MEETING OF THE DESIGN REVIEW BOARD

Project # SPR24-000012

A public hearing to reconsider an application by MTTR MGMT, as agent for the property owner Shaul Dina Trust, requesting approval for a new multi-family residential complex (La Jolla at 10084 West Bay Harbor Drive) on the property located at 10084 West Bay Harbor Drive, identified by parcel identification number 13-2227-008-0011.

10084 W Bay Harbor Dr
Permit Number: SPR24-000012
February 26, 2026
Revision 5 Narrative to DRB

SITE PLAN
3/32" = 1'-0" 3

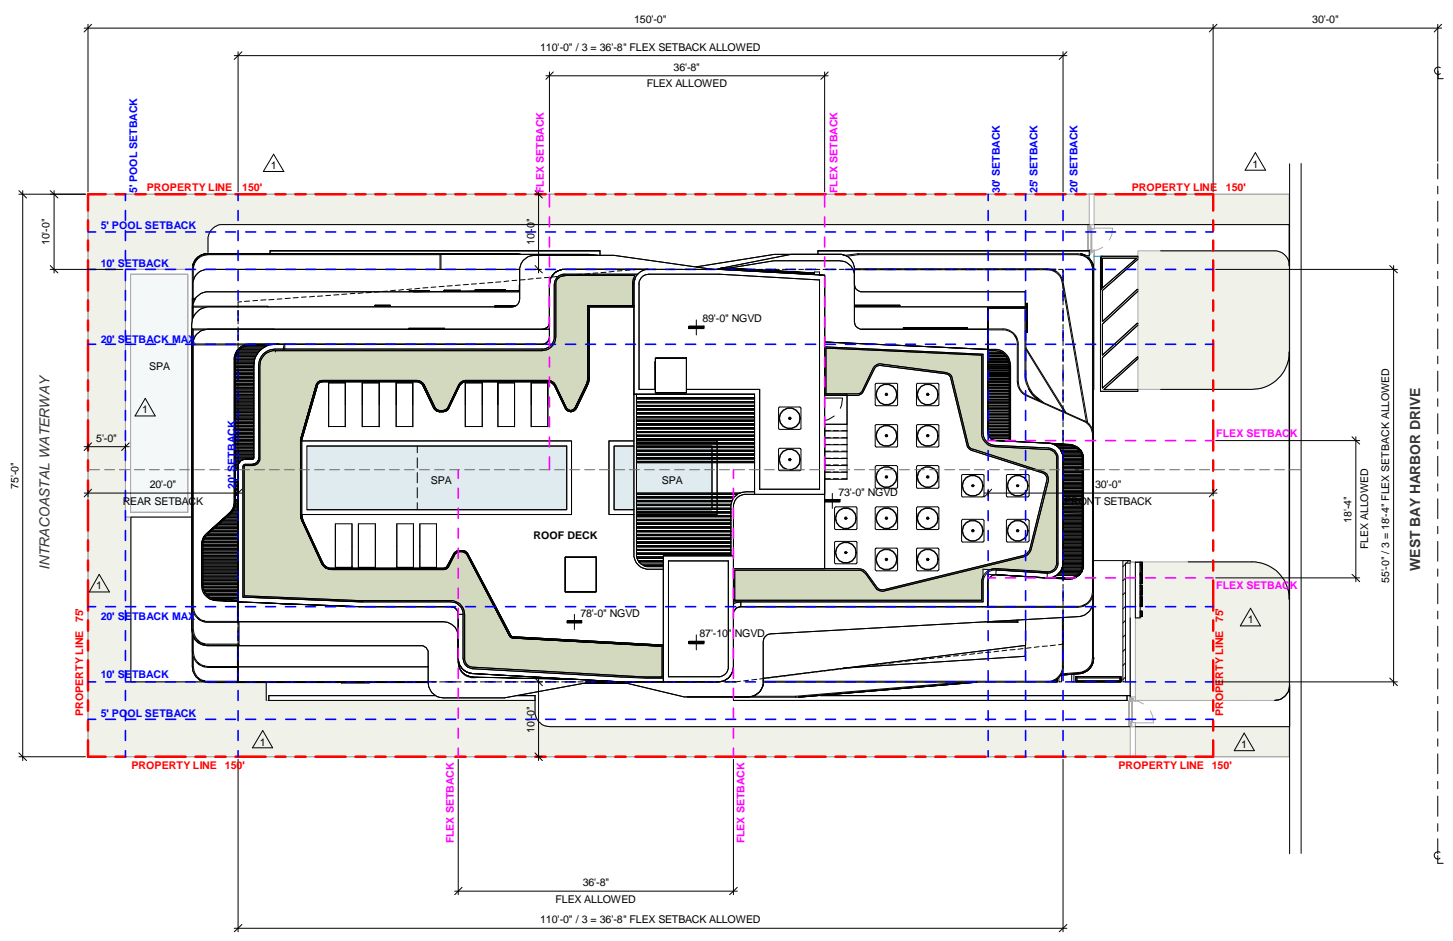
1. Comment: The zoning data must be updated to reflect the correct zoning setbacks.
2. Response: The zoning data has been updated to reflect the correct zoning setbacks.

GROUND FLOOR SITE PLAN

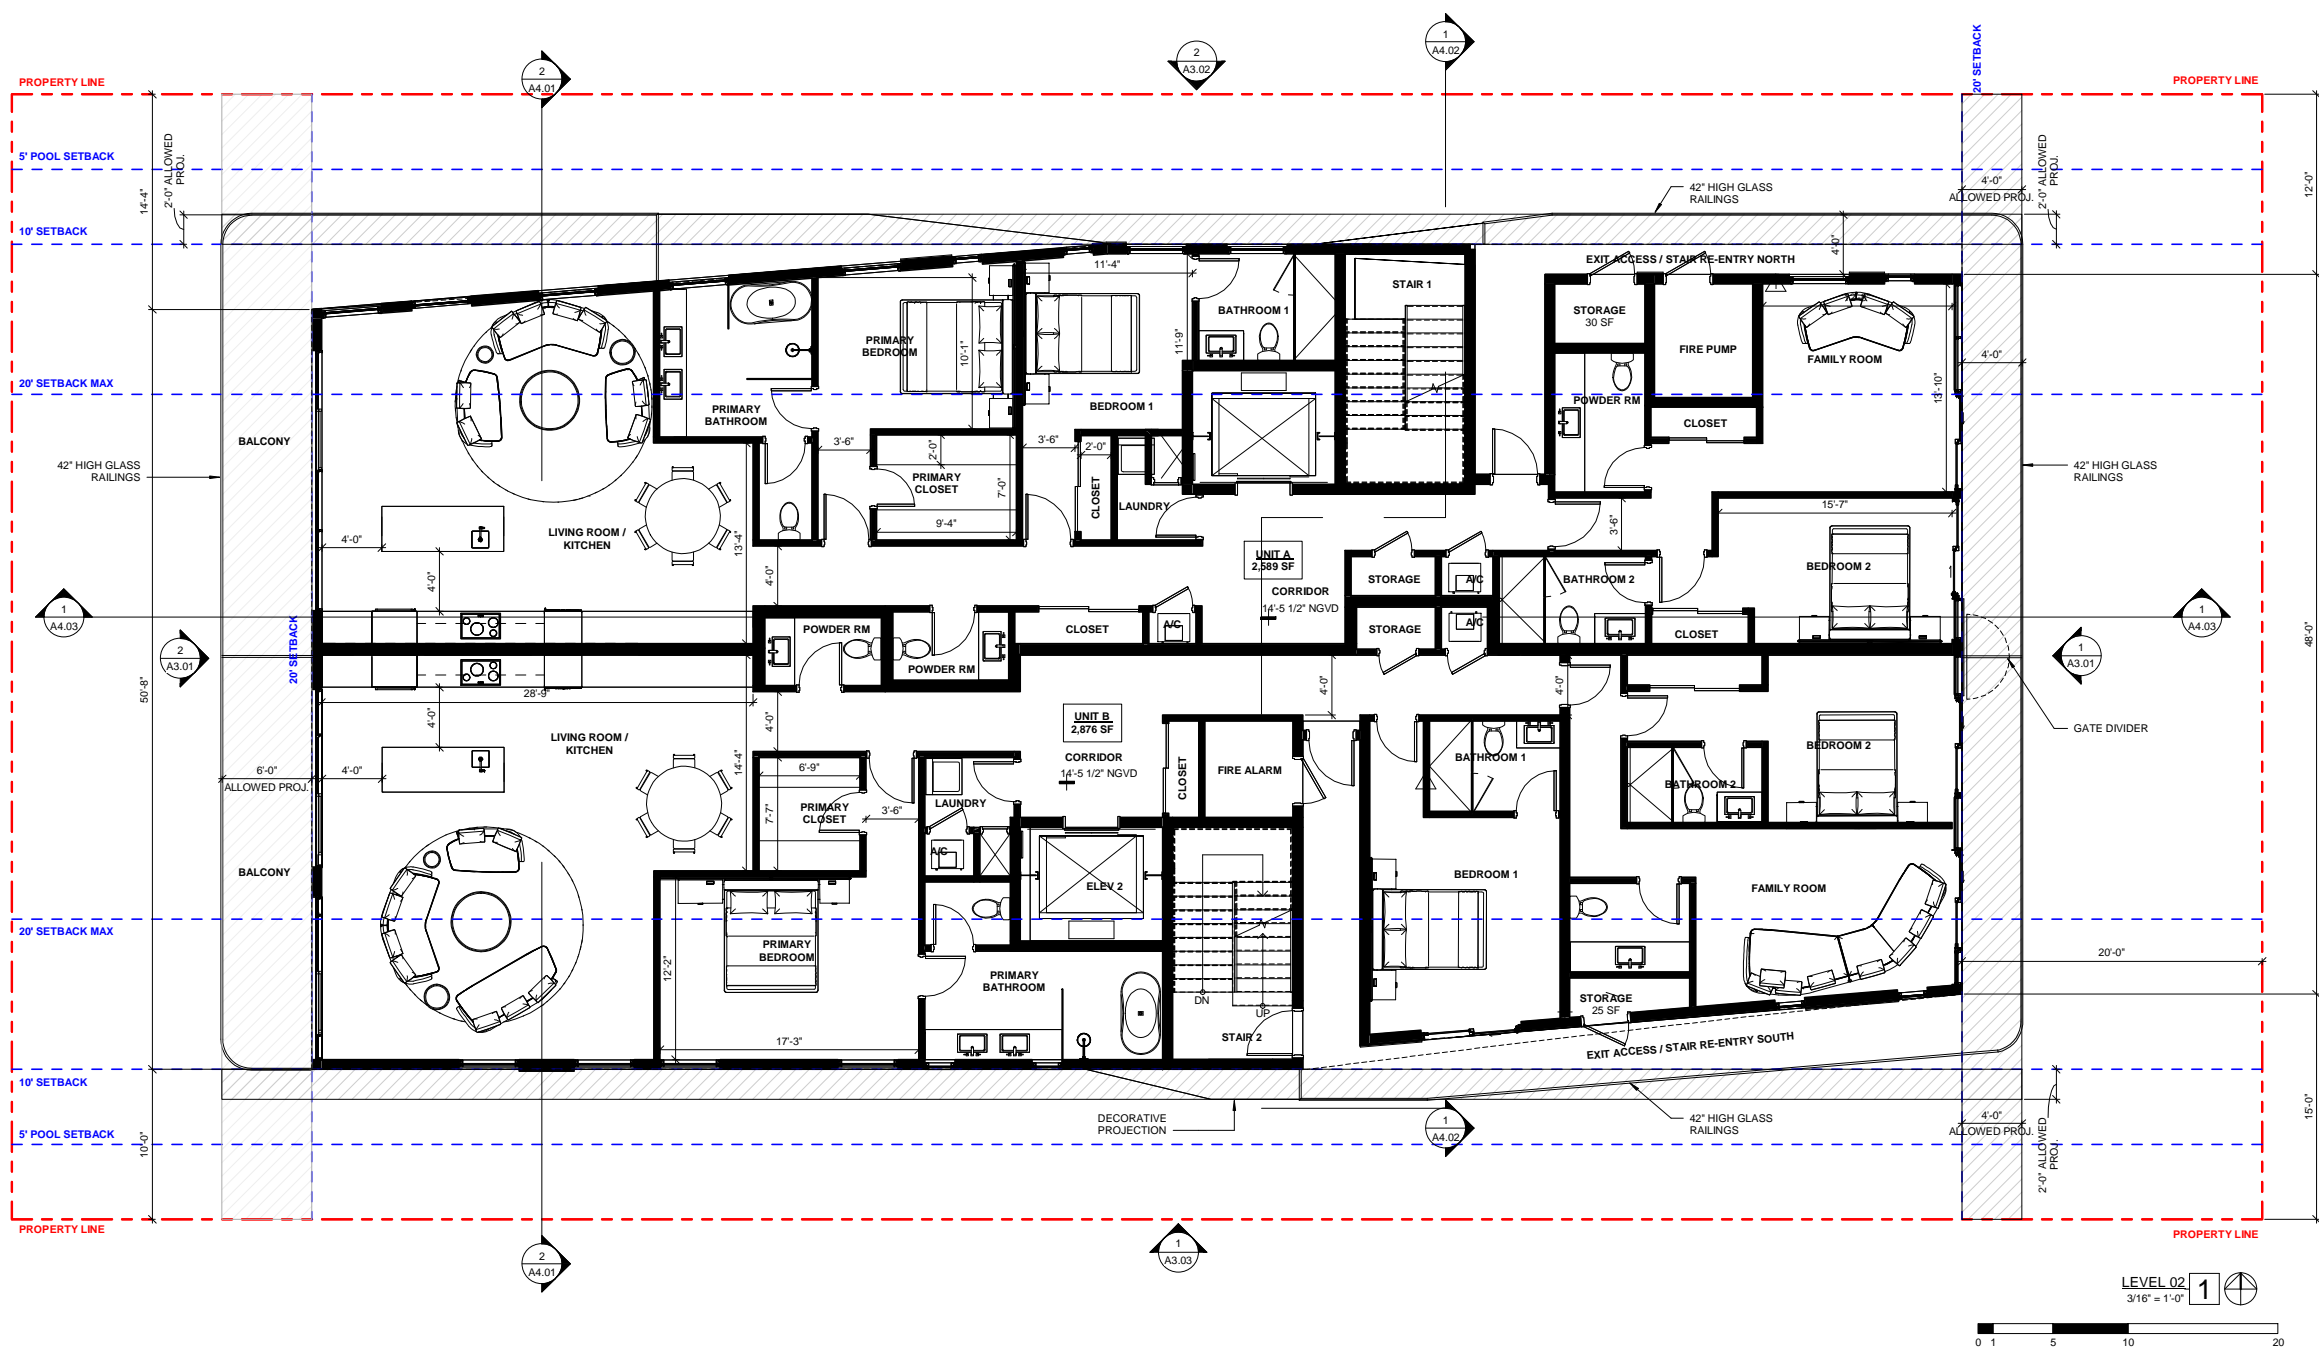
- **Comment:** Address the 7' planting strip in front of the property (the minimum is 10').
 - **Applicant Response:** The architect has completely redesigned the parking layout to accommodate the required 10-foot minimum wide planting strip on both sides of the driving aisle access. This modification brings the project into full compliance with Sec. 24-16 and eliminates the need for a waiver for the landscape strip width. Staff confirms that the parking space has been removed from the buffer area, and the required 10-foot planted strip is now provided.

In response to the Board's concerns and public comment, the applicant has reconfigured the site plan to remove the parking space that previously sat within the required 10-foot front landscape strip. As confirmed in the February 20, 2026 Letter of Intent, the plans now show full compliance with the 10-foot landscape buffer, with the exception of the driveway approach itself which must cross the buffer to provide access. Staff finds this modification acceptable as it achieves the core purpose of the landscape code by providing an unobstructed, planted area between the street and the paved parking areas. **No waiver is required for the landscape strip width.**

PARKING SCREEN 11
1/8" = 1'-0"

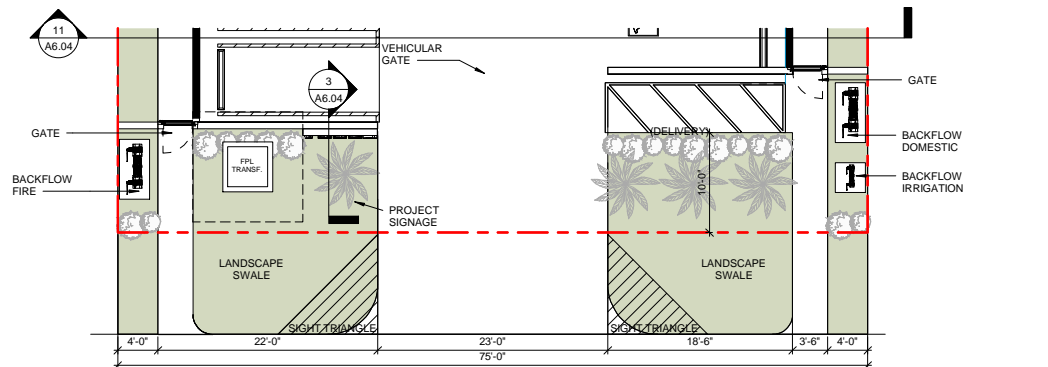
- **Comment:** The wall that encloses the parking area still doesn't solve and address car visibility from neighboring properties.
 - **Applicant Response:** The architect has made two significant modifications. First, the screening wall has been increased in height from 4'-6" to 6'-0" feet tall. Second, the perimeter screen has been lowered by a module to minimize the opening gap. The revised design ensures that the parking is visually shielded from neighboring properties while retaining necessary ventilation properties. This addresses light pollution and privacy concerns.

2. Garage Enclosure Waiver: This approval is contingent upon the DRB APPROVING the applicant's request pursuant to Sec. 23-24 to provide a suitable alternative (6-foot wall with louver system and architectural screens) to a fully enclosed parking garage.
